# SHOP DRAWING TRANSMITTAL

Project: Turnbull School Music Room Addition Project No: 1705  
Date: December 10, 2018  
To: TALCO Building Innovations Ltd.  
Attn: Farah Bano (fbano@tal-co.com)  
From: Michelle Cataldo

Shop Drawing Submittal: Division 08 – Windows & Doors  
Submitted by: Centennial Glass Depot  
Drawing Title: Drawings 1, 2, 3, and 4  
Revision No. N/A  
Dated: December 6, 2018

TURNBULL SCHOOL MUSIC ROOM ADDITION		
SCALE: 1:30	APPROVED BY:	DRAWN BY
DATE: NOV/2018		REVISED
CENTENNIAL GLASS DEPOT		
HOBIN ARCHITECTURE		DRAWING NUMBER 10F4

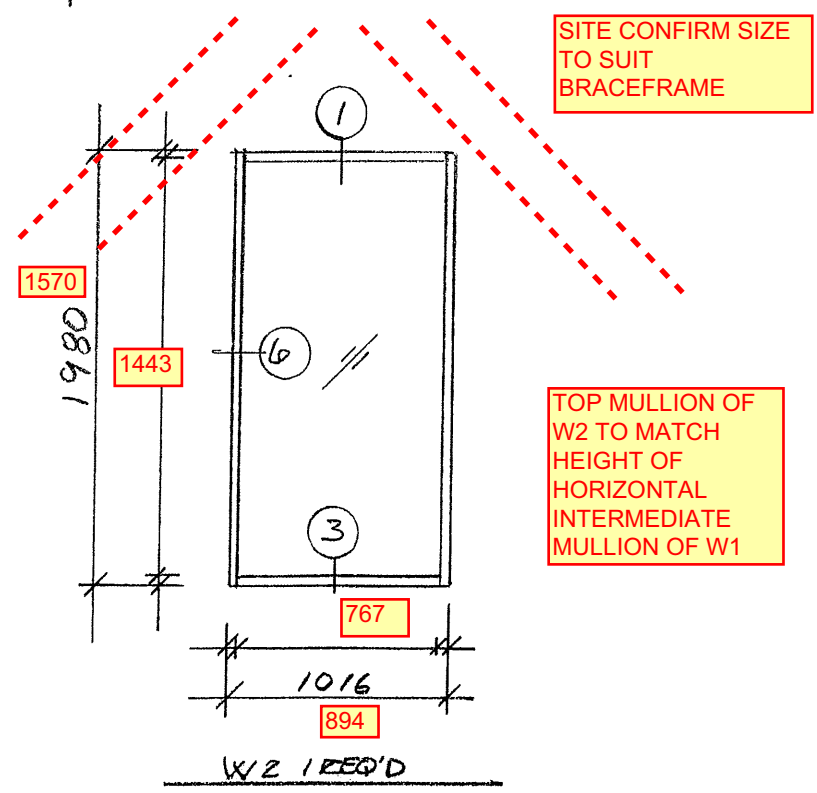
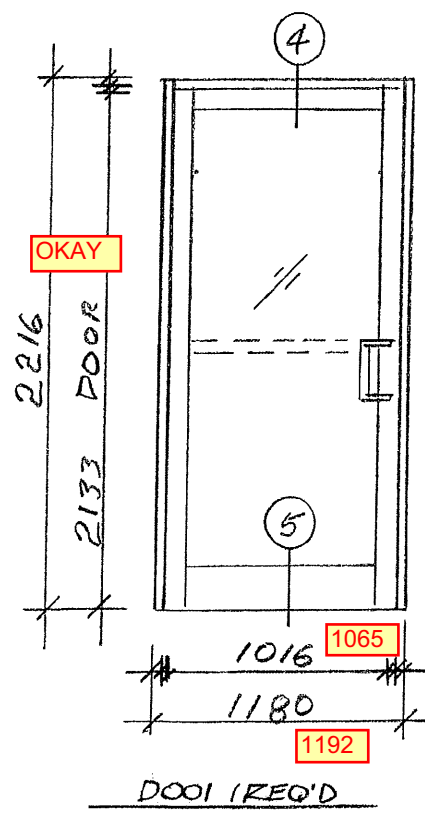
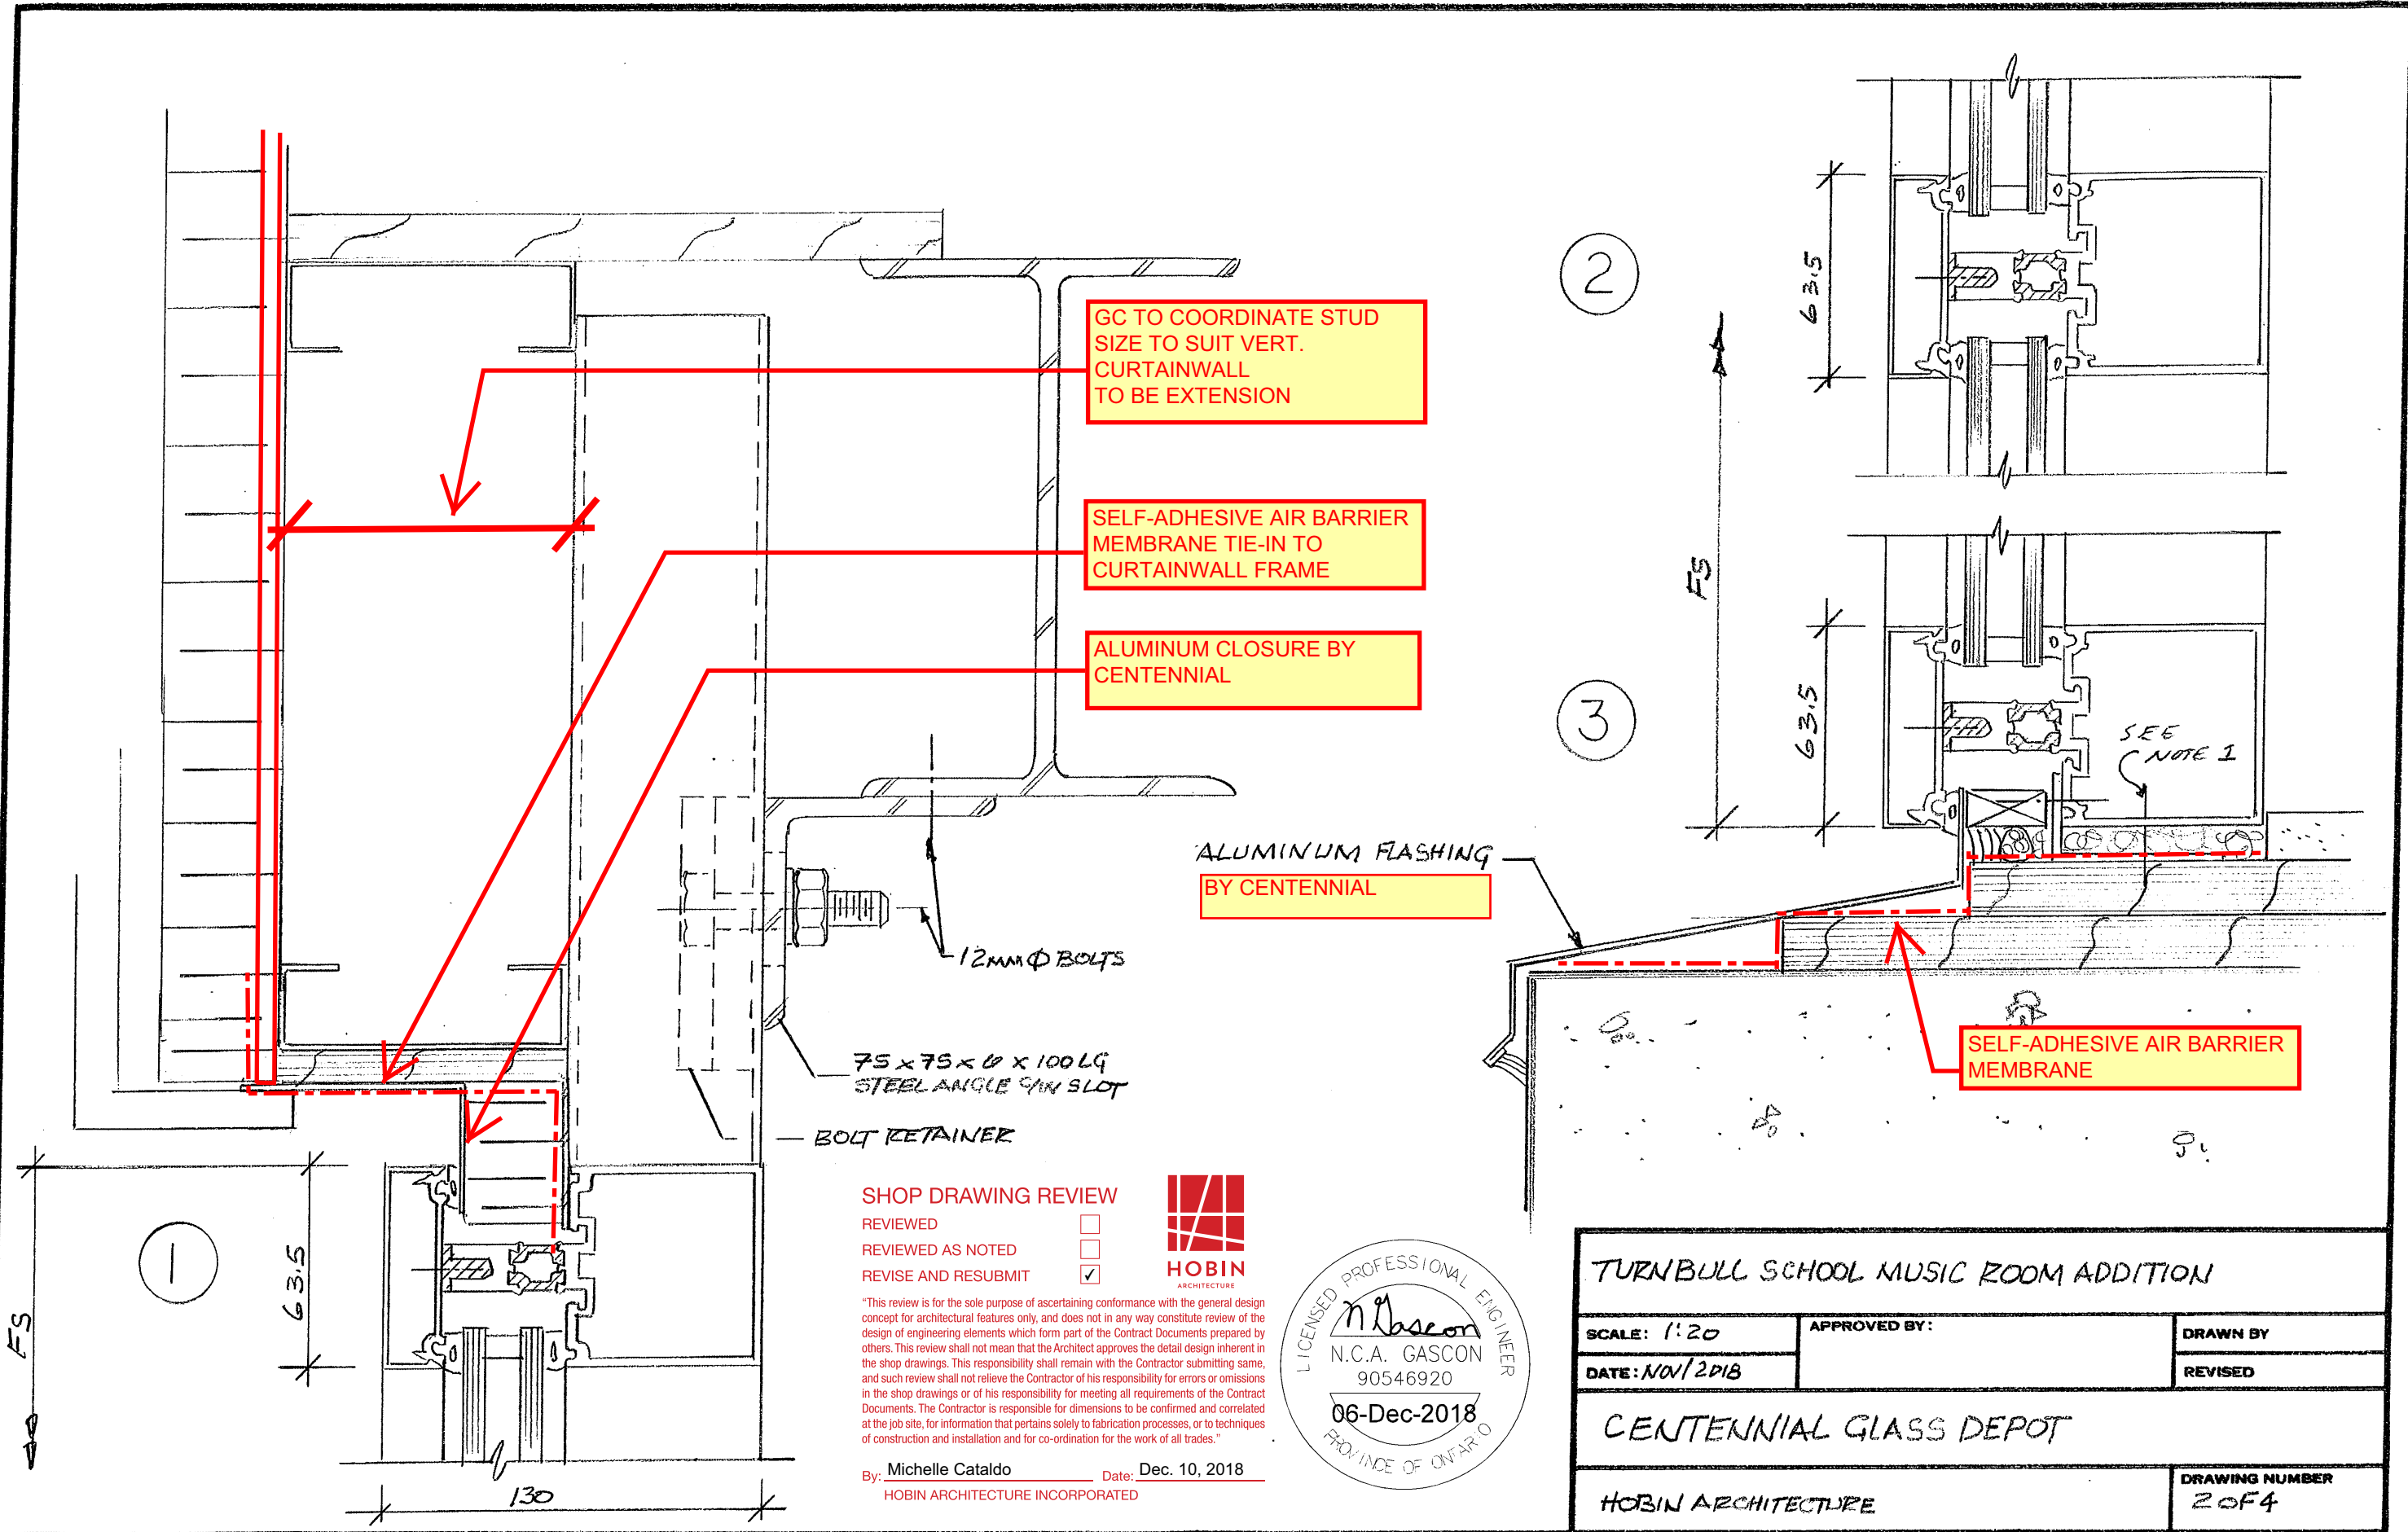
ALL SIZES TO BE SITE CONFIRMED ✓

SITE CONFIRM SIZE TO SUIT BRACEFRAME

- ✓ **Finish:** Clear anodized. "HTC?" **5500 HTC**
- Framing:** Windspec 5500 HTP, 63.5mm x 130mm overall.
- ✓ **Glazing:** 6mm ✓ tempered SolarBan 60 on surface #2, 6mm ✓ tempered clear interior, black warm edge spacer,
- ✓ **Argon gas.** ✓

- Frame Finish:** Clear ~~anodized~~. "UC40597 XL" as per CIR # 14
- ✓ **Door Finish:** Duranar XL Exotic U40597 Banner Red.
- Door:** Windspec 500 HTP widestile. **500 HTC**
- ✓ **Glazing:** As per W1/W2.

TURNBULL SCHOOL MUSIC ROOM ADDITION		
SCALE: 1:20	APPROVED BY:	DRAWN BY
DATE: NOV 2018		REVISED
CENTENNIAL GLASS DEPOT		
HOBIN ARCHITECTURE		DRAWING NUMBER 2 OF 4

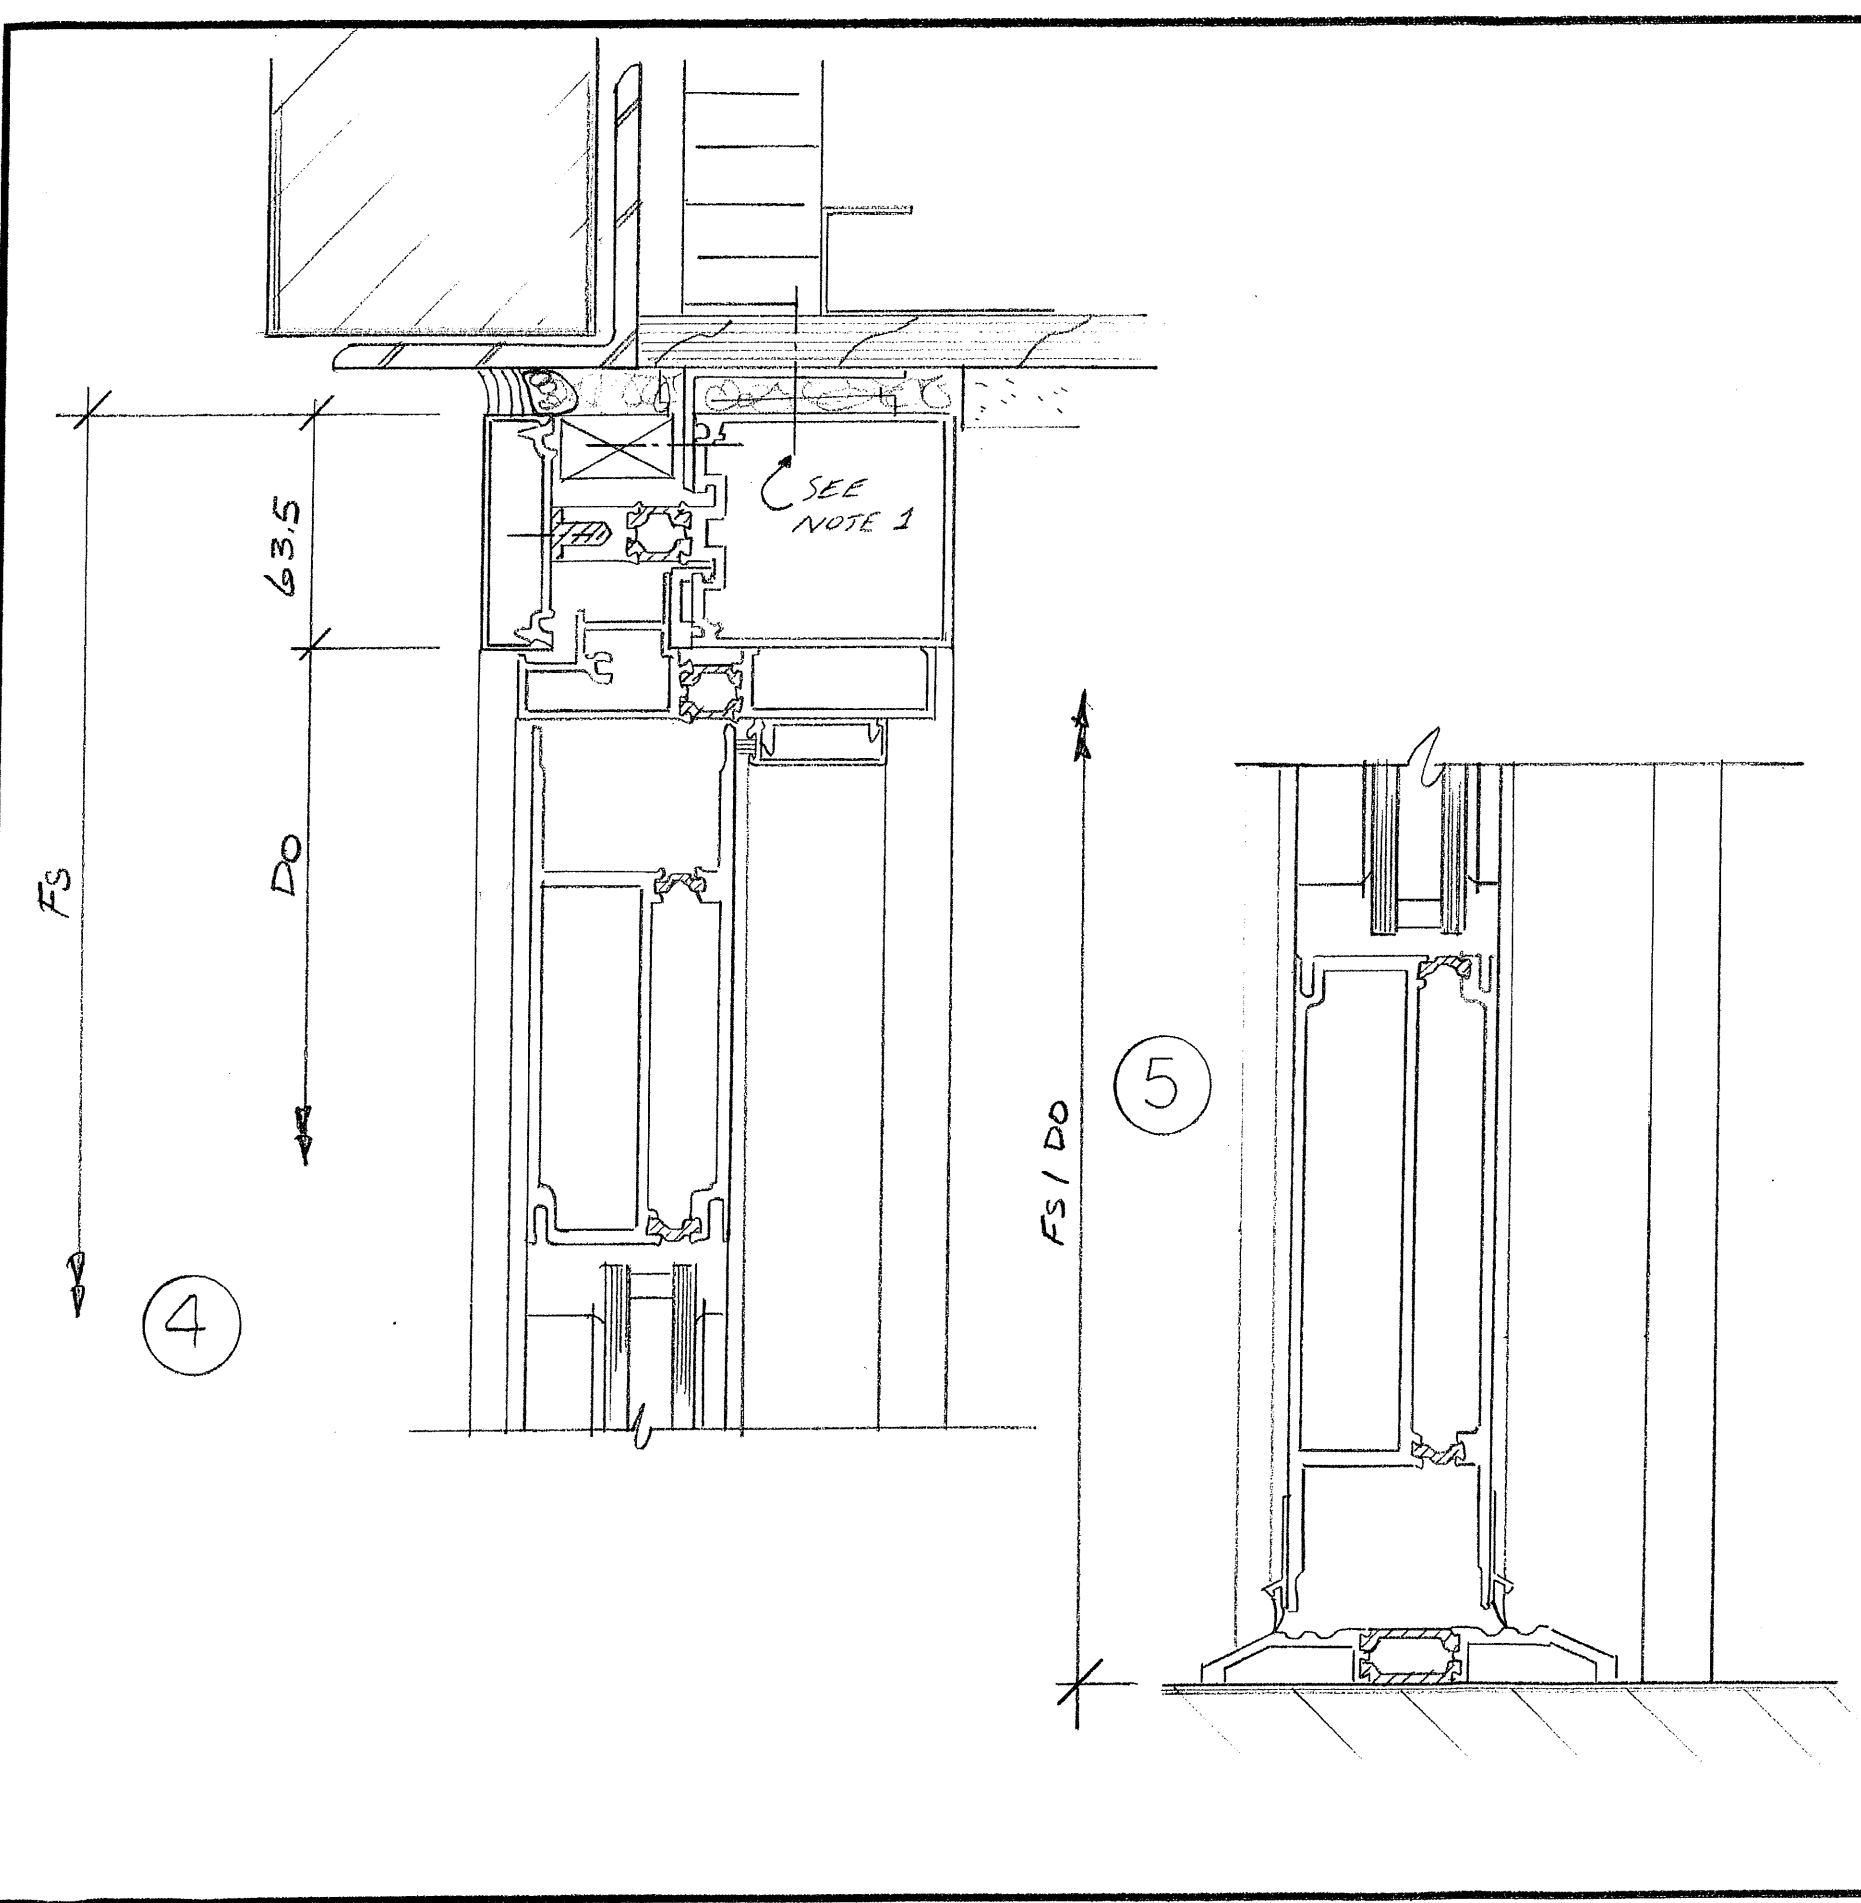
GC TO COORDINATE STUD SIZE TO SUIT VERT. CURTAINWALL TO BE EXTENSION

ALUMINUM CLOSURE BY CENTENNIAL

ALUMINUM FLASHING BY CENTENNIAL
